#	Date	Issue / Description
01	05/02/16	1ST PLANNING SUBMITTAL
02	09/15/16	2ND PLANNING SUBMITTAL

# METRO CENTER

**ALAMEDA PARKWAY & SABLE BLVD.  
AURORA, CO 80012**

**WOODBURY CORPORATION**

TITLE:  
ENLARGED LANDSCAPE PLAN  
STREET B & MAIN STREET

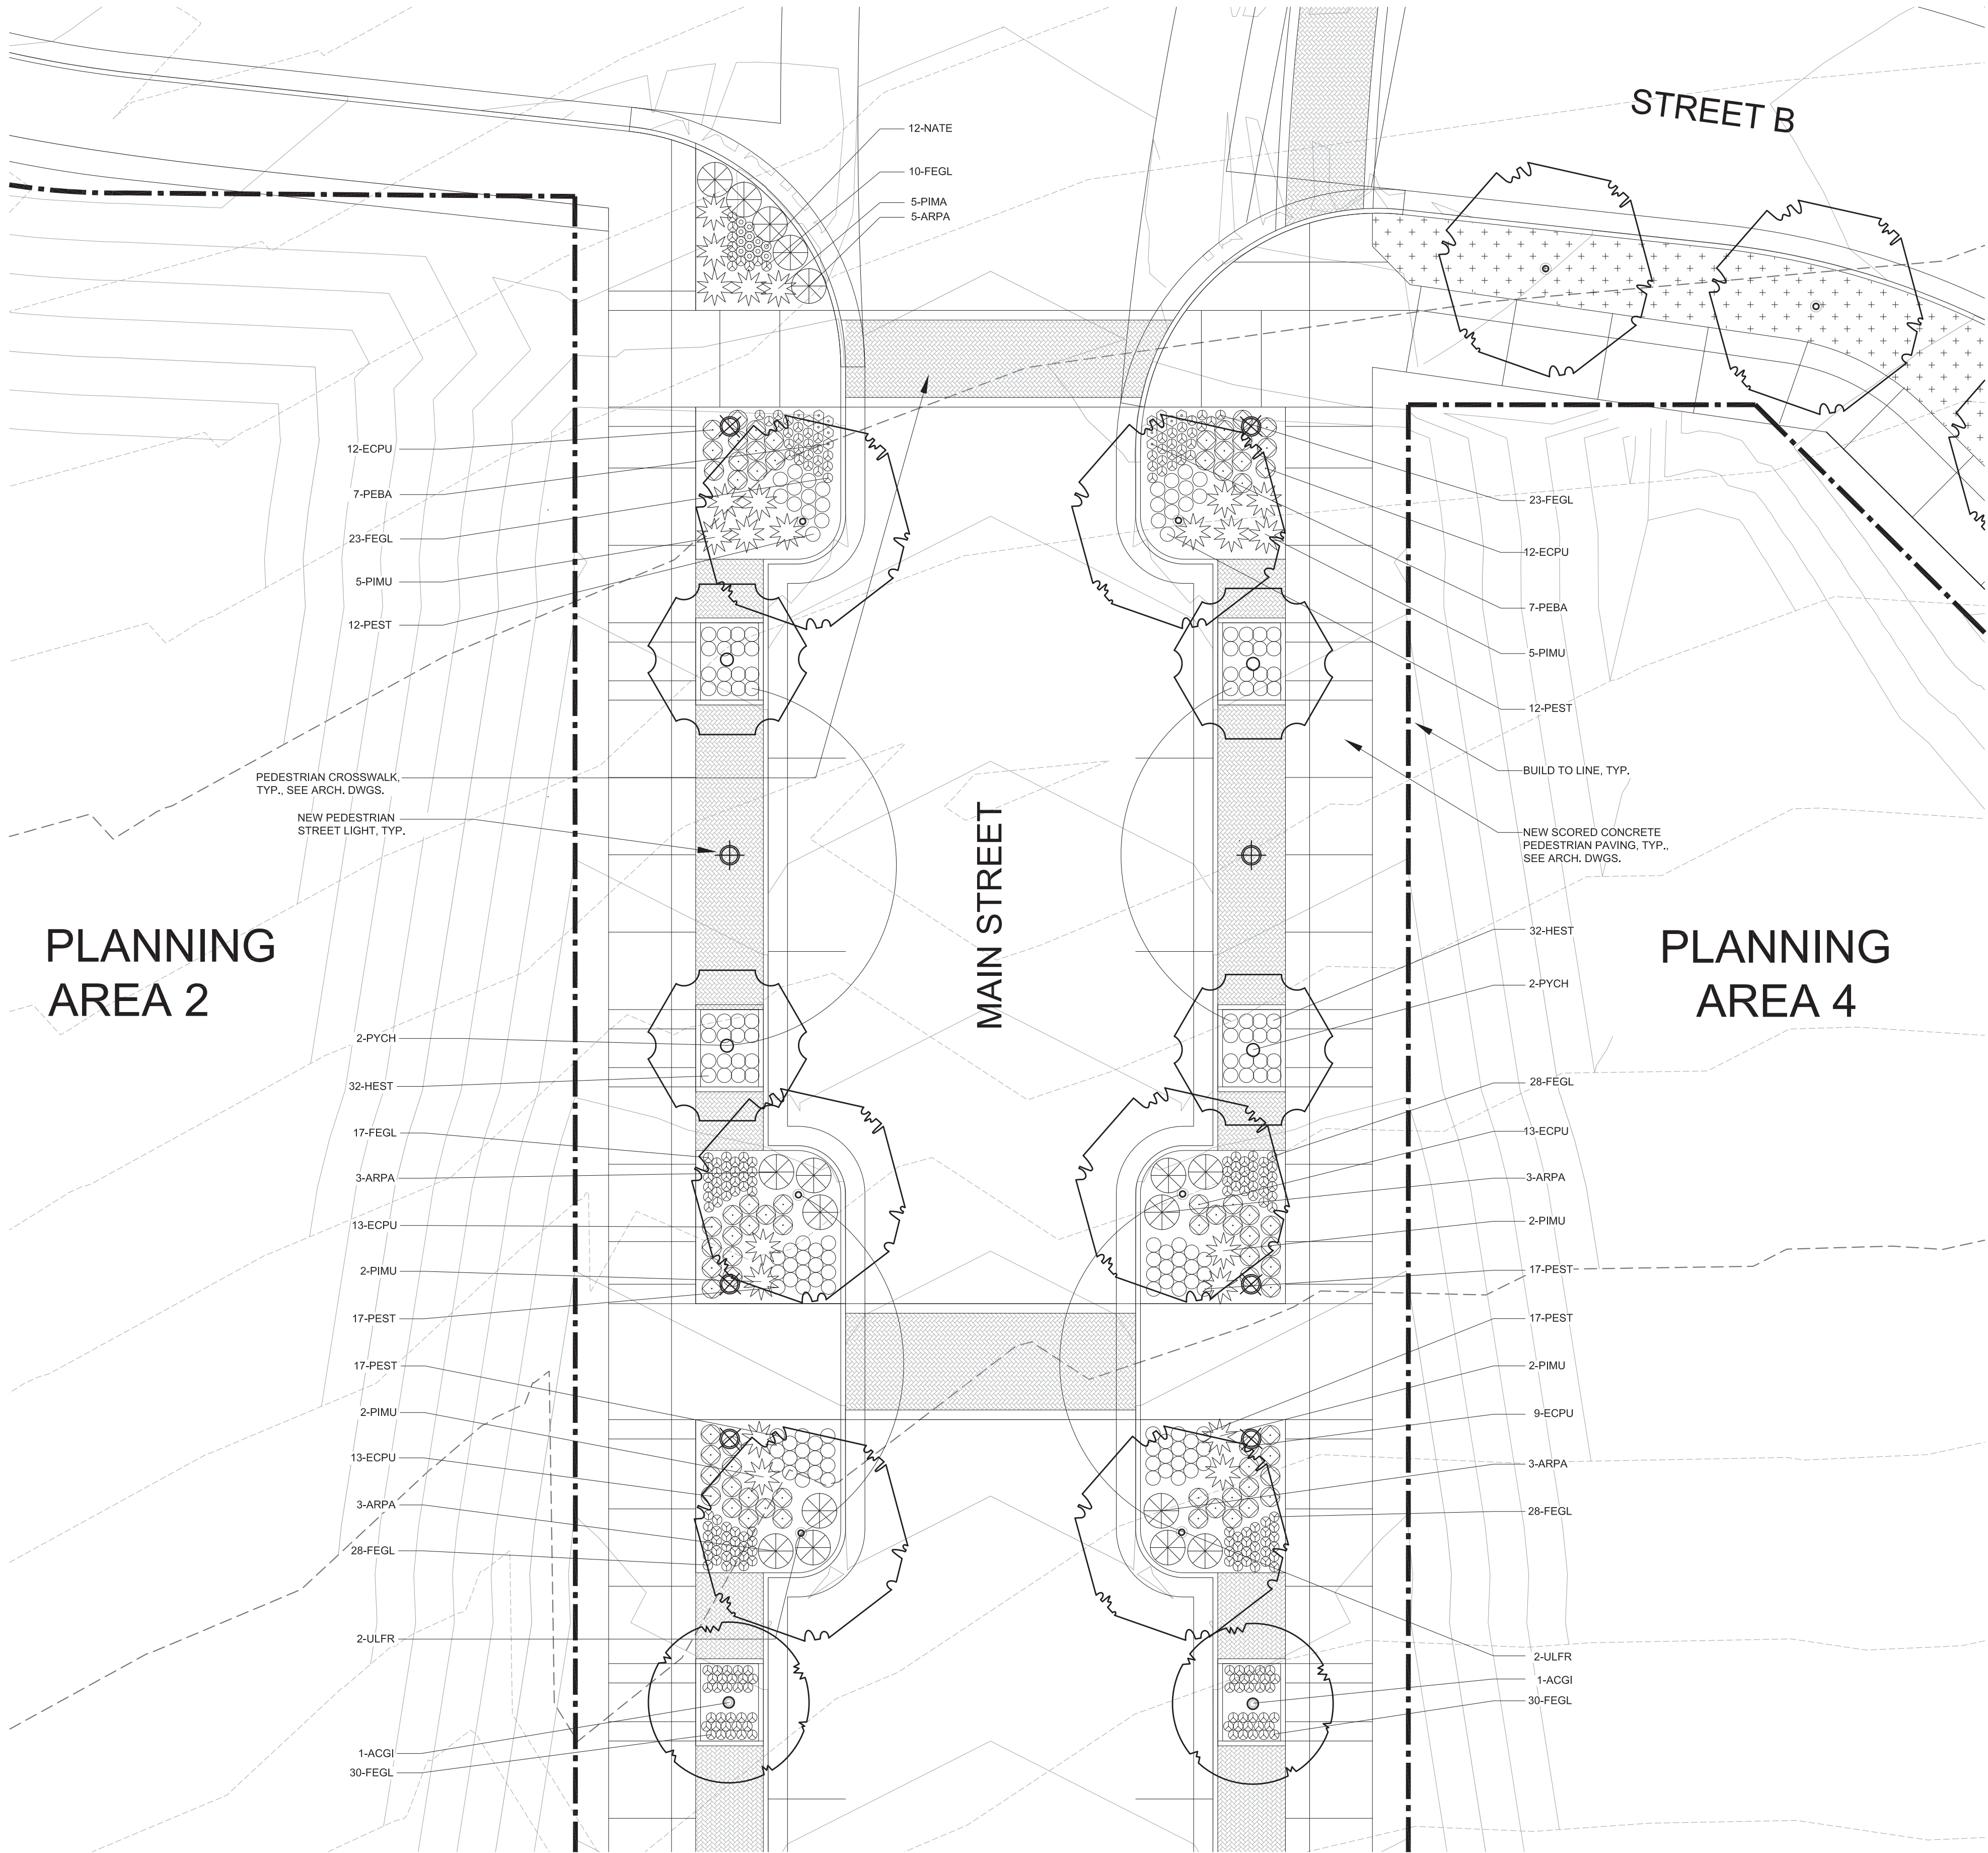
Did the hydraulic modeling for the stormwater overflow through this easement and the culvert structure account for the roughness introduced by all this landscaping? This is the major flood conveyance route is it not?

LANDSCAPING  
HAS BEEN  
REVISED

ENLARGED LANDSCAPE PLAN  
PARK / OPEN SPACE

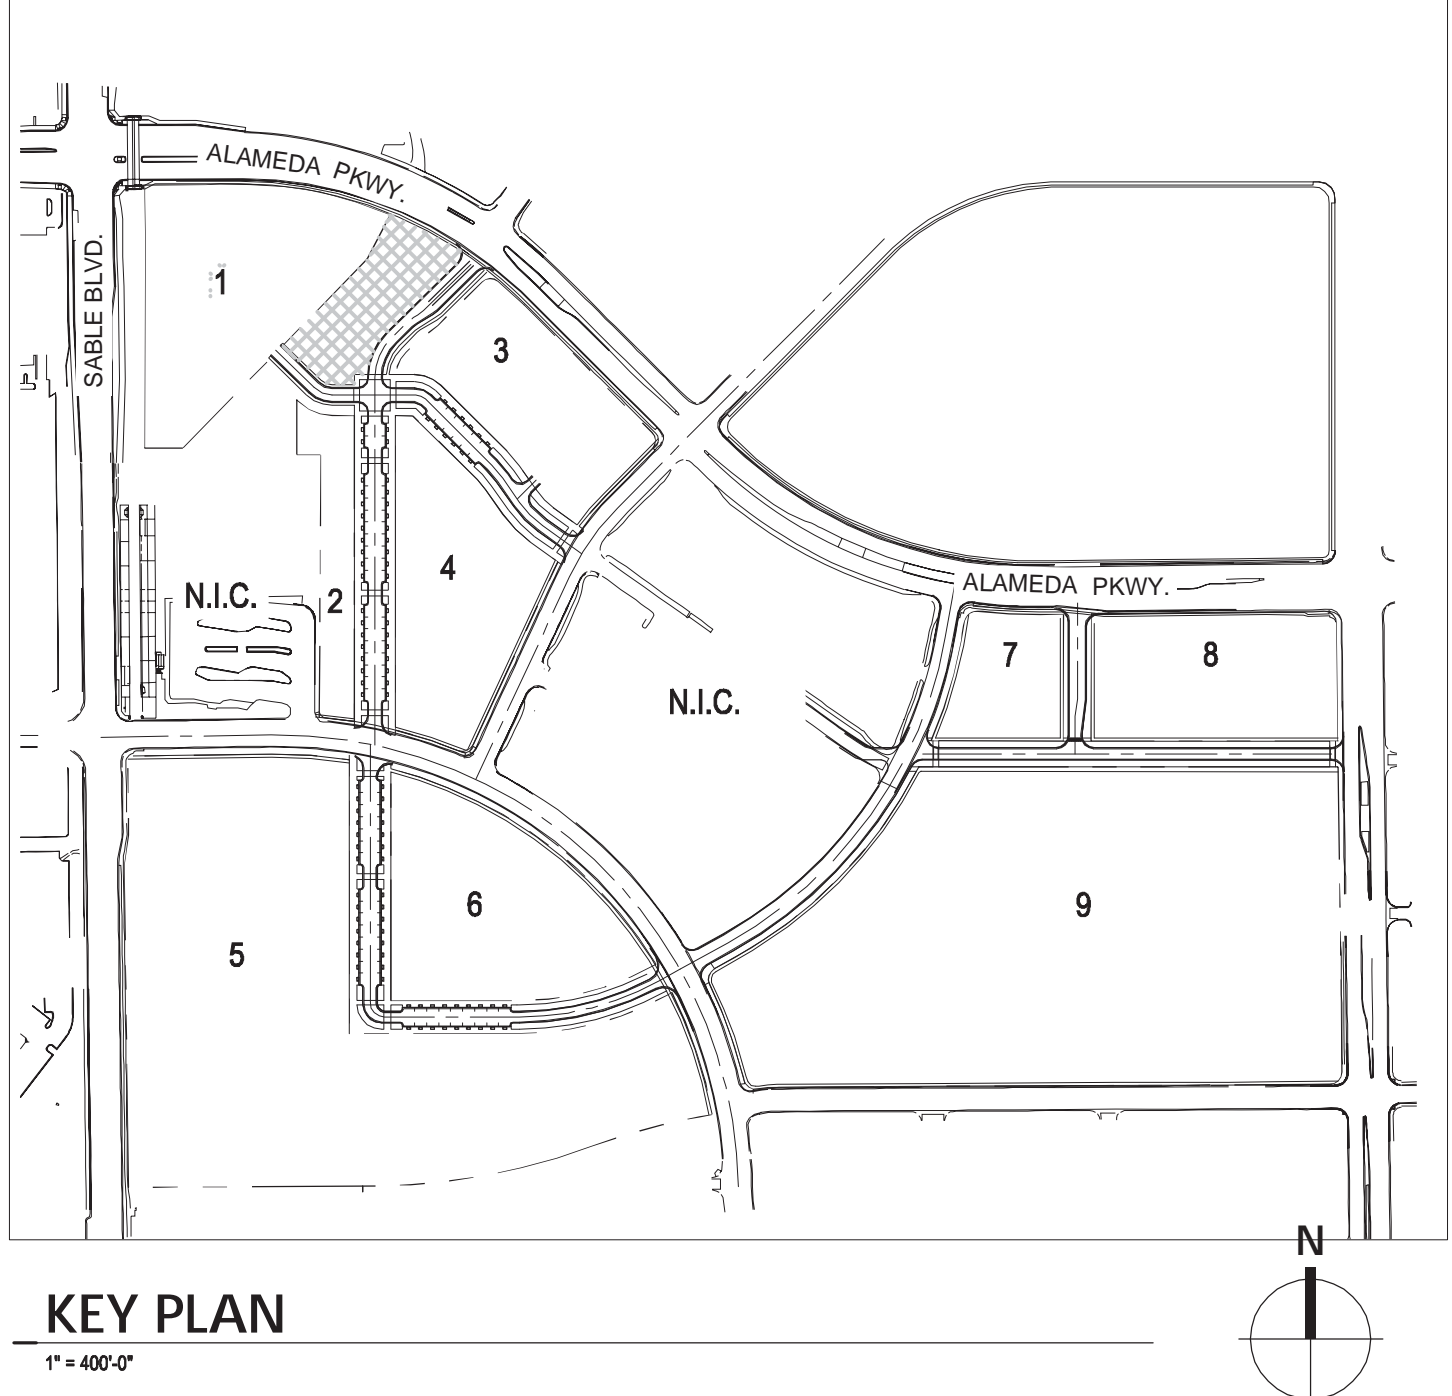
NICE FEATURE;MAKE THIS  
FEEL/LOOK SLIGHTLY  
DIFFERENT THAN THE OTHER  
SMALL PLAY AREA.

PLANTING SCHEME INCLUDES AN EXTREMELY LARGE NUMBER OF PLANTS AND SPECIES; WE HAVE 2 CONCERNS; FIRST, THIS NUMBER OF PLANTS WILL REQUIRE A LOT OF MAINTENANCE AT A LARGE COST TO THE DEVELOPER; IF THE DEVELOPER CANNOT COMMIT THE DOLLARS NECESSARY, THE LANDSCAPE WILL SUFFER; SECOND, FILLING UP THE CORRIDOR WITH PLANTS WILL MAKE IT SEEM SMALLER THAN IT IS; WITHIN AN URBAN AREA, OPEN AREAS ARE AT A PREMIUM AND APPRECIATED FOR THE RELIEF THEY OFFER FROM THE BUILT ENVIRONMENT; FEWER PLANTS AND LARGER NATIVE GRASS AREAS COULD TAKE ADVANTAGE OF THIS CORRIDOR AND THE SPACE IT PROVIDES; A LANDSCAPE WITH THIS MANY PLANTS IS NOT NECESSARY TO SATISFY THE SMALL URBAN PARK REQUIREMENTS.

SHOW THE PROPOSED DRY UTILITY SLEEVES AND AVOID PLANTING TREE AND LARGE SHRUBS OVER THEM

SHOW/LABEL  
THE TREATMENT  
ON GRADE  
UNDER THE  
BRIDGE.

BECAUSE THIS TRAIL CORRIDOR/OPEN SPACE IS THE ONLY PORTION OF THE SITE THAT CAN HELP TO SATISFY THE DEVELOPMENT'S COMMUNITY PARK REQUIREMENTS, IT MAY BE DESIRABLE TO USE PART OF THE AREA TO SATISFY THE COMMUNITY PARK REQUIREMENTS AND PART (OR MULTIPLE PARTS) TO MEET THE NEIGHBORHOOD PARK REQUIREMENT (BY BEING A SMALL URBAN PARK): CONSIDER THIS OPTION

VIEWS TO THE TRAIL ARE  
IMPORTANT TO TRAIL USER SAFETY.  
IDENTIFY MULTIPLE VIEW  
CORRIDORS FROM ADJACENT  
STREETS TO THE TRAIL (ESPECIALLY  
THE UNDERPASS AND UNDER THE  
BRIDGE) AND REMOVE THE TREES  
AND SHRUBS THAT ARE IN THE WAY  
OF THESE VIEWS

DESIGN BY  
OTHERS, AND  
NOTED AS SUCH

PHASING PLAN  
PLANNING AREA 2

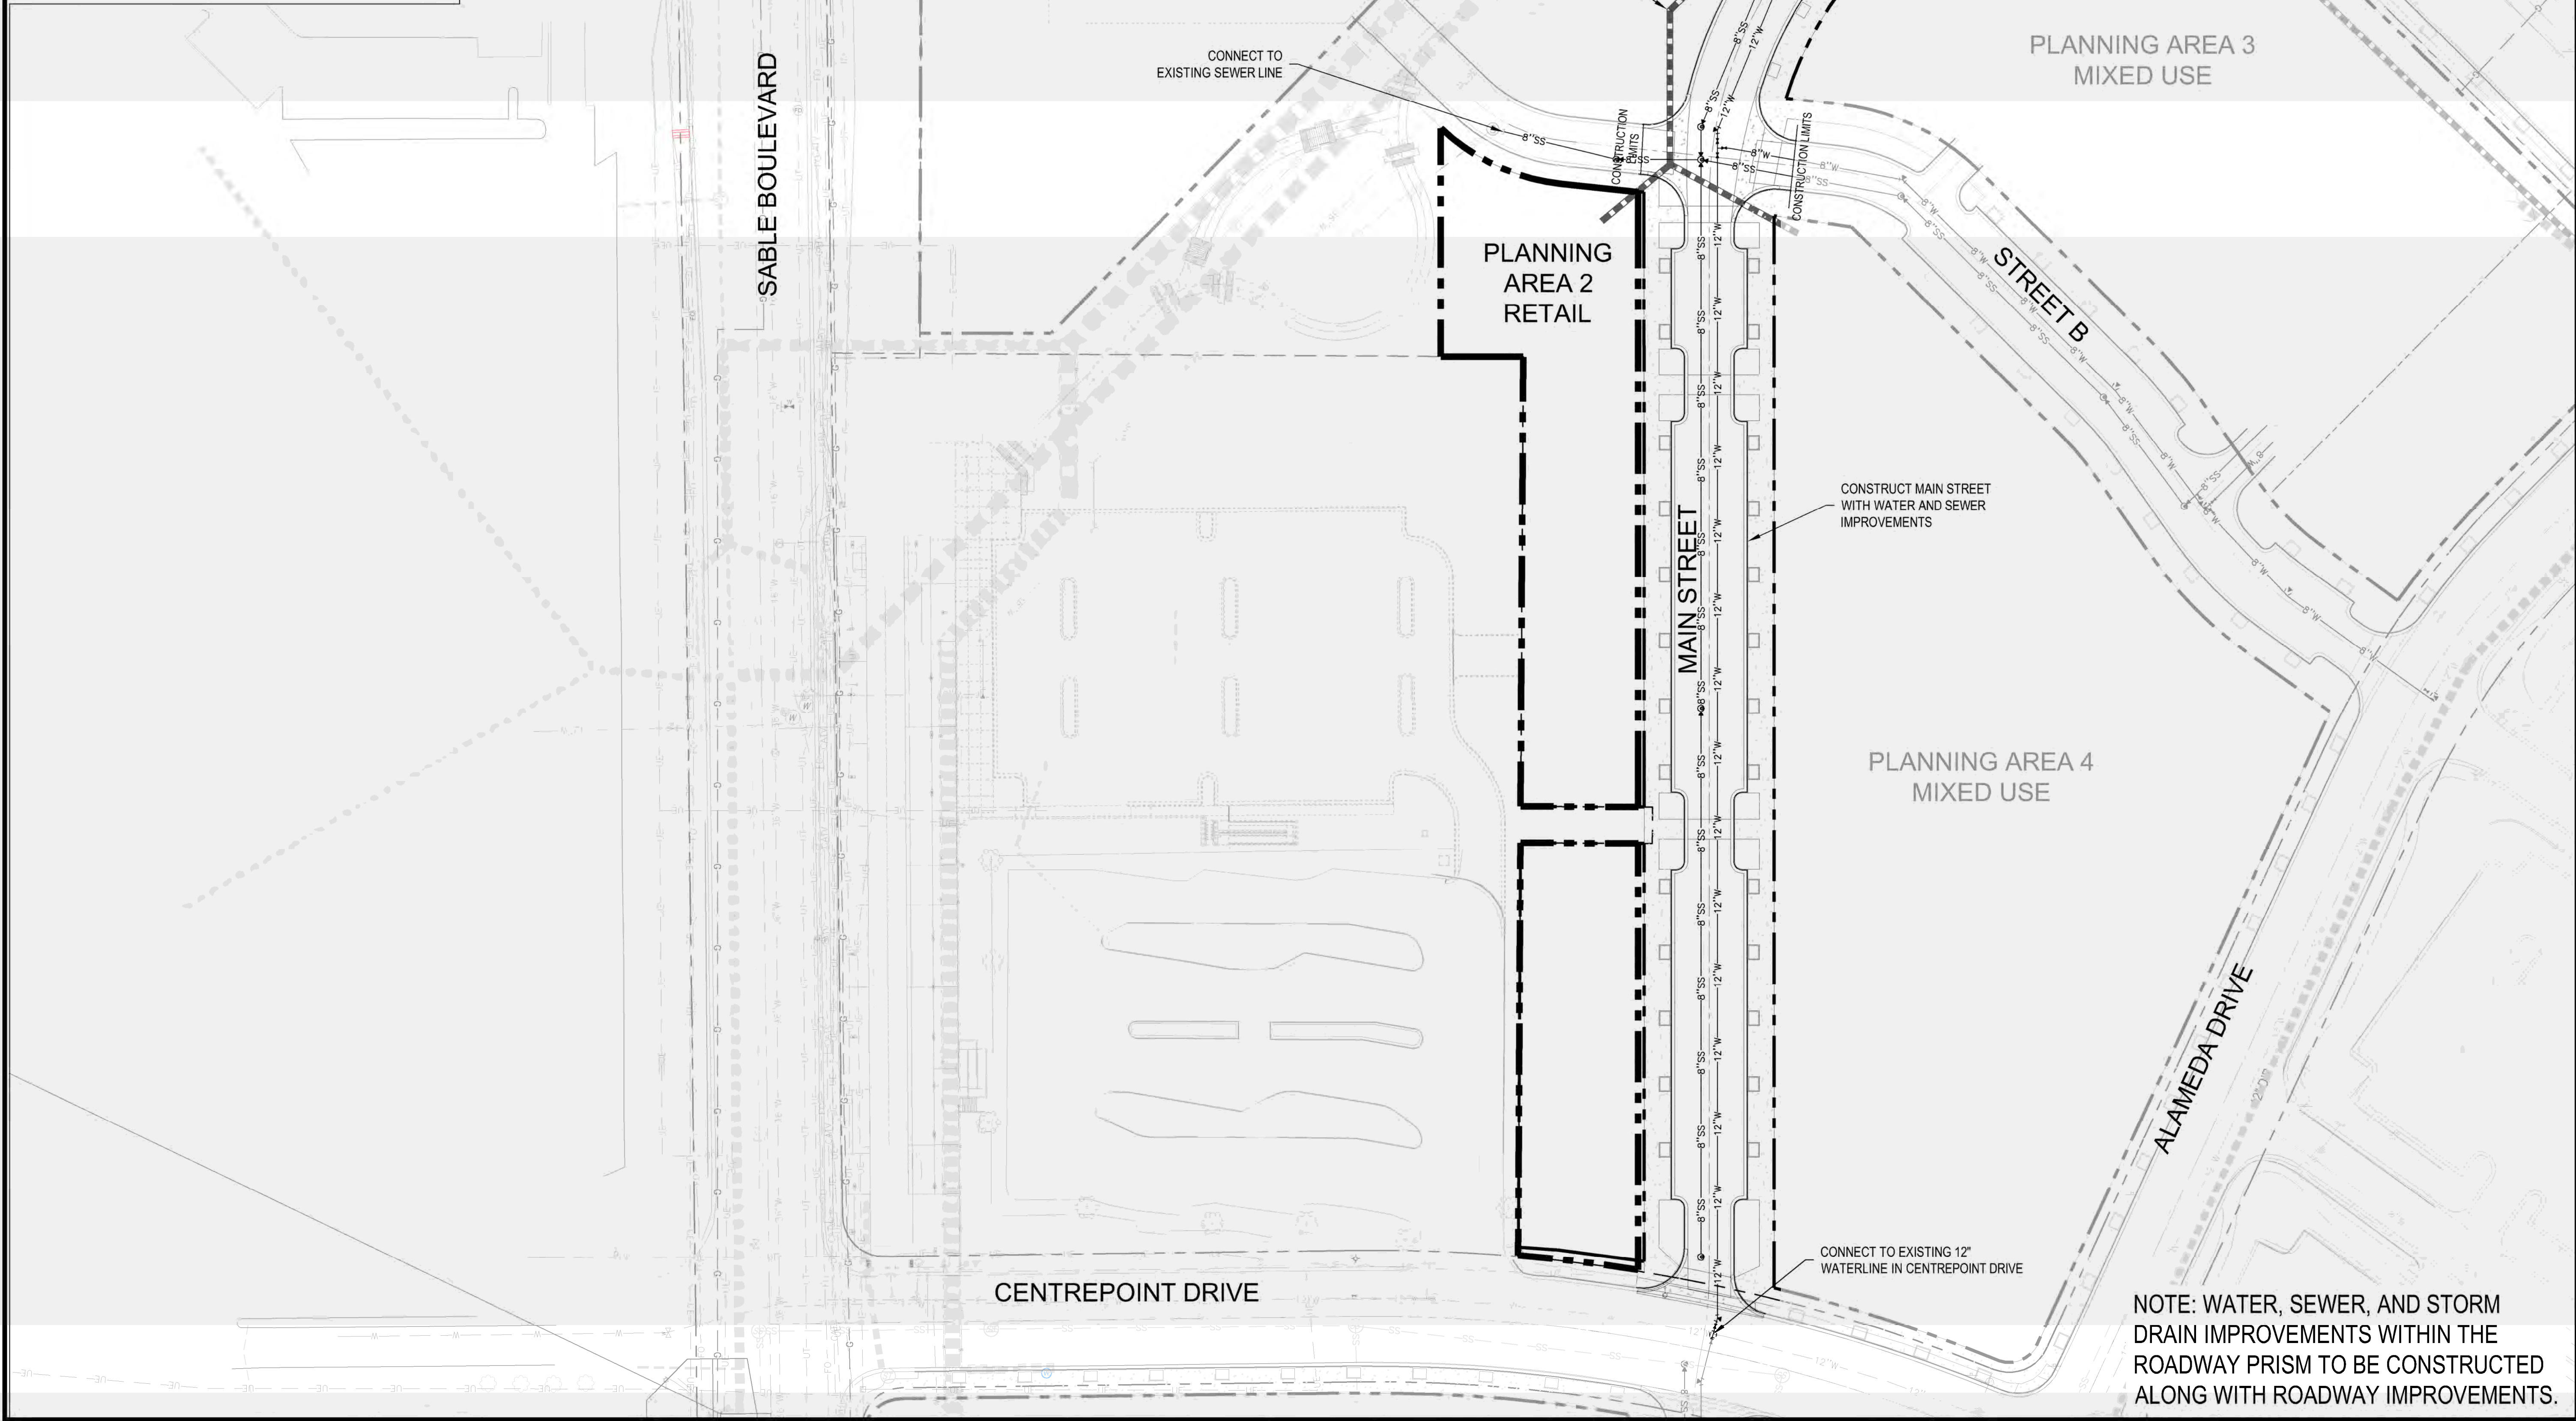
ADD "CONSTRUCT ALL STREETSCAPE IMPROVEMENTS WITHIN EXISTING STREET RIGHTS-OF-WAY"
